Service Letter No. 336

SUBJECT: Modification of Oil Pressure Lines

MODELS AFFECTED: PA-23 and PA-23-160 Apaches Serials 23-1 to 23-1390 inclusive

19148-00

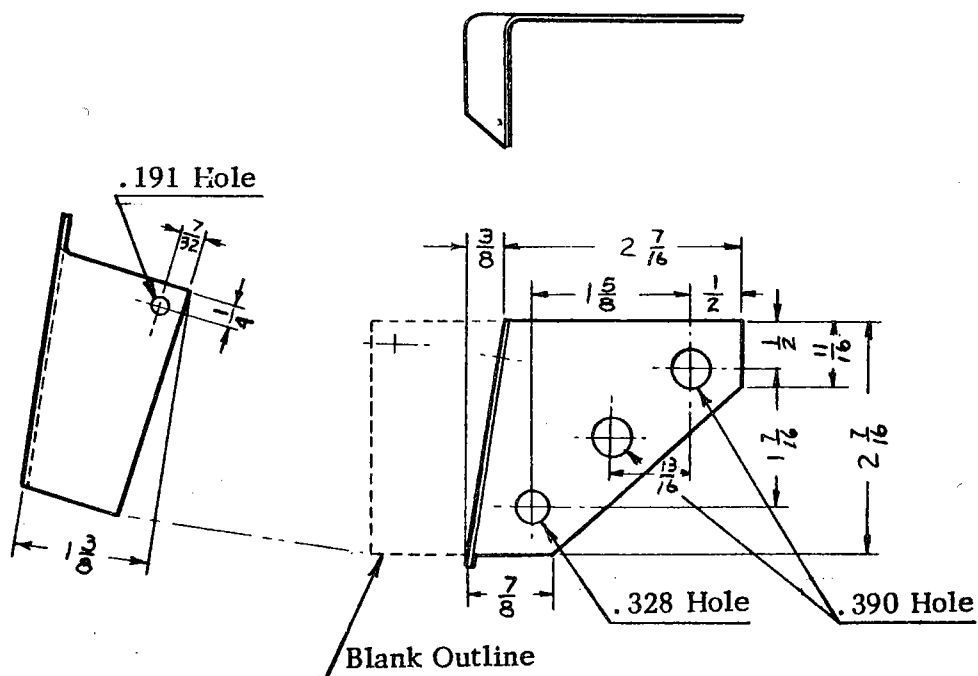
This Service Letter is to advise that beginning with Apache Serial No. 23-1221 and up a clamp (Tinnerman [A-4980S-3-91]) was installed on the oil pressure line, each firewall, as indicated on the sketch shown on the reverse side of this Service Letter.

Further modification to each firewall was made, beginning with Serial No. 23-1391 and up. This is also shown on this sketch, plate #19148-00.

These modifications were made to provide a more rigid mounting of the oil pressure line on the firewall and to minimize the possibility of cracks or breaks developing in the oil pressure line flares.

Note #1 - Use existing screw that attaches firewall to engine mount.
